Class II permissive change Request

Model No.: mBS1100 FCC ID: 2AG32MBS1100 Granted on: 06/01/2016

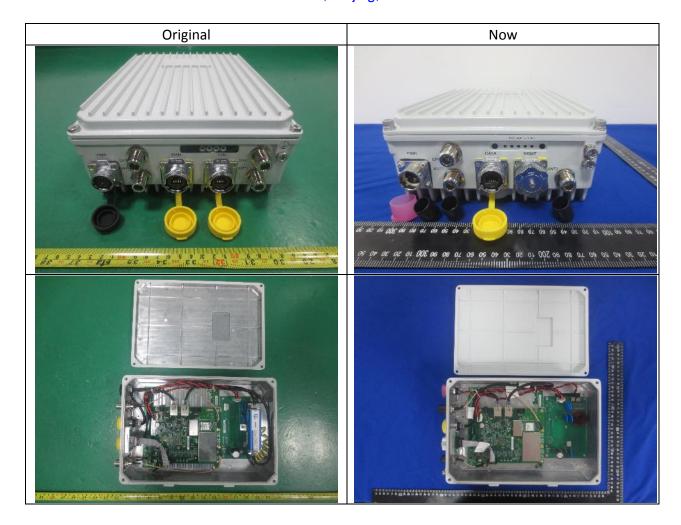
- 1) Remove the SNF interface, SNF interface is used to time synchronization, meanwhile, GPS has the same function, so the SNF interface was not applied in communication network, and the new equipment remove the SNF interface, the GPS interface was retained, the hardware of the equipment was not changed,. So remove the SNF interface don't affect any RF parameters.
- 2) Change LAN port to MGMT port for software upgrade.
- 3) Change the baseband board
 - Add several tantalum capacitors on the output of the DC/DC converters;
 - Move J10 faraway from the board edge to reduce the EMI;
 - Remove three capacitors C693, C692, C765 to reduce the EMI;
- 4) Remove the Lightning protection components
- 5) No RF parameters and unrestricted contention based protocol changes.
